GXW4501/4502/4504 Firmware Release Notes

FIRMWARE VERSION 1.0.1.13

GXW4501/GXW4502/GXW4504

Figure 1 - SS7 Data Channel Selection

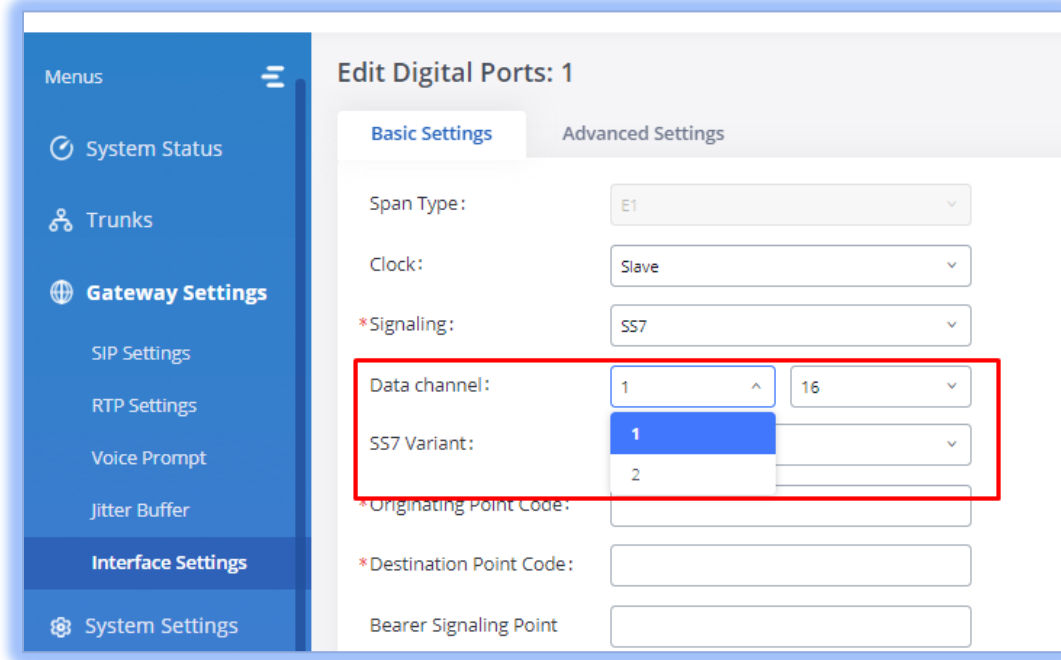
Users can now specify a different E1/T1 port to use for each port's data channel when SS7 is selected as the signaling type. The first dropdown list specifies the E1/T1 port to use. The second dropdown list specifies the channel to use for data connections.

Figure 2 - TLS Security

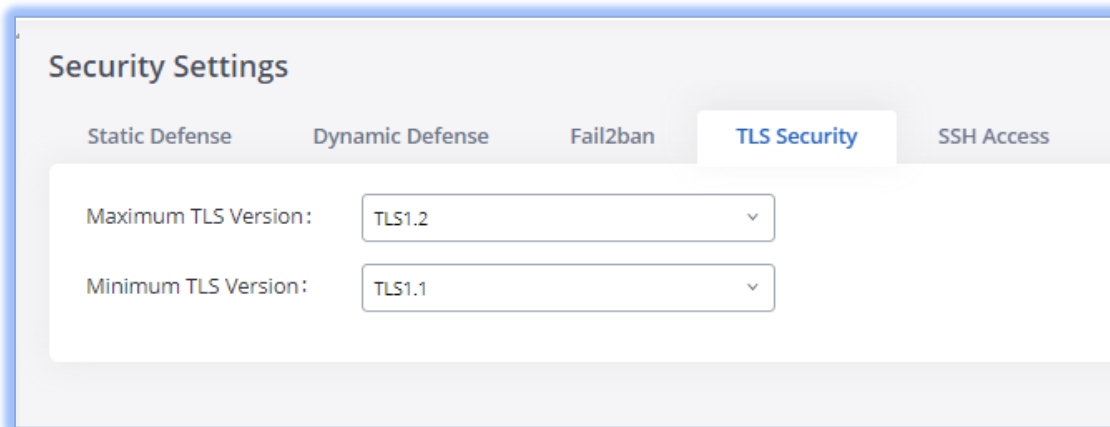
Users can now select the minimum and maximum versions of TLS for the GXW450x to support. The setting can be found under *System Settings* → *Security Settings* → *TLS Security* page.

Figure 3 - SNMP page

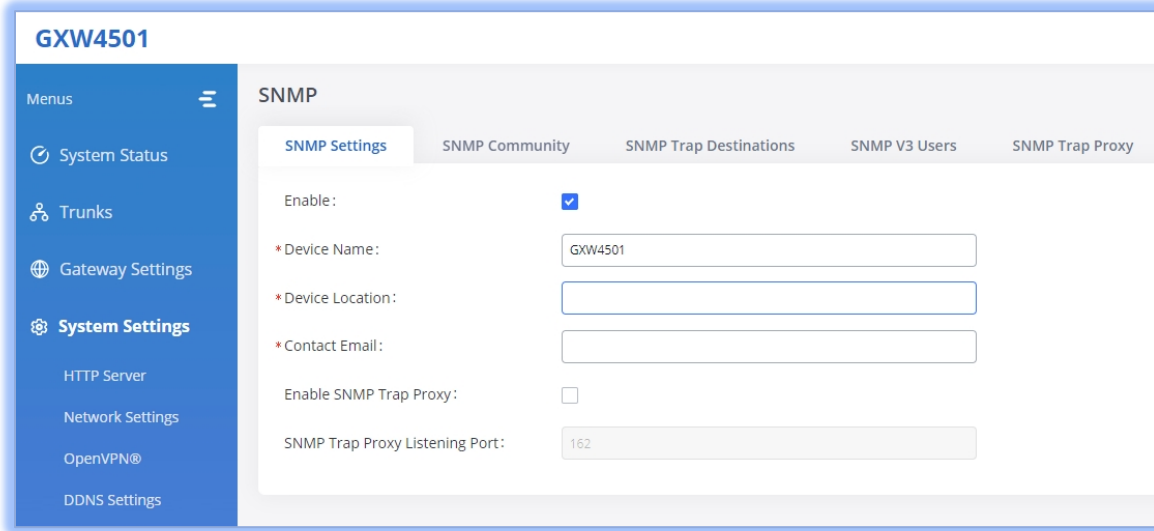
SNMP is now available and can be configured from *System Settings* → *SNMP*.

Figure 4 - SNMP Community

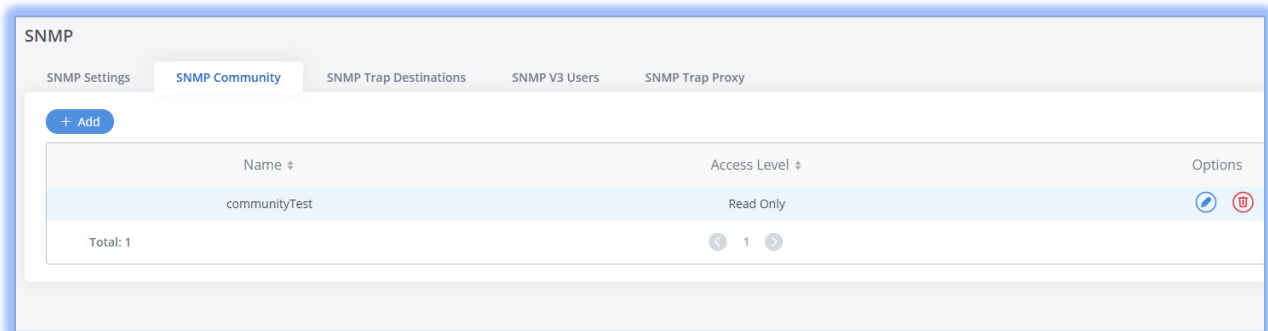
The SNMP Community page allows users to configure the GXW450x's community strings, allowing it to determine whether or not to respond to SNMP requests from clients. Two access levels are available: Read Only and Read/Write.

Figure 5 - SNMP Trap Destinations

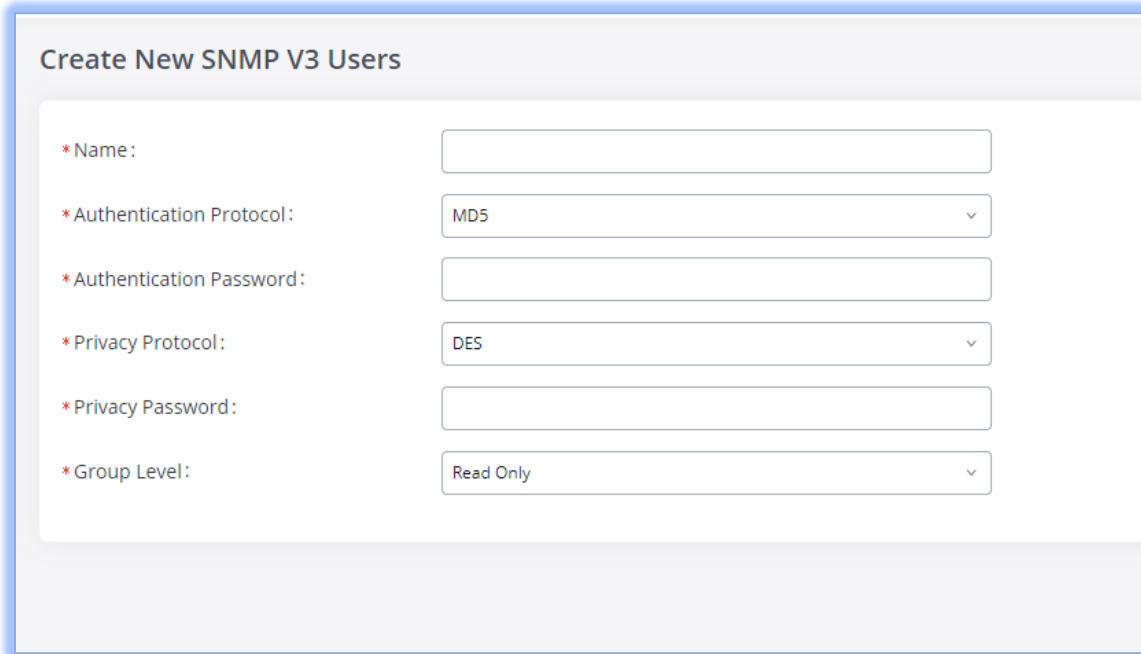
In the **SNMP Trap Destinations** page, users can point to where the device's traps should be sent to, set

the community string to use, and specify the type of notifications to send.
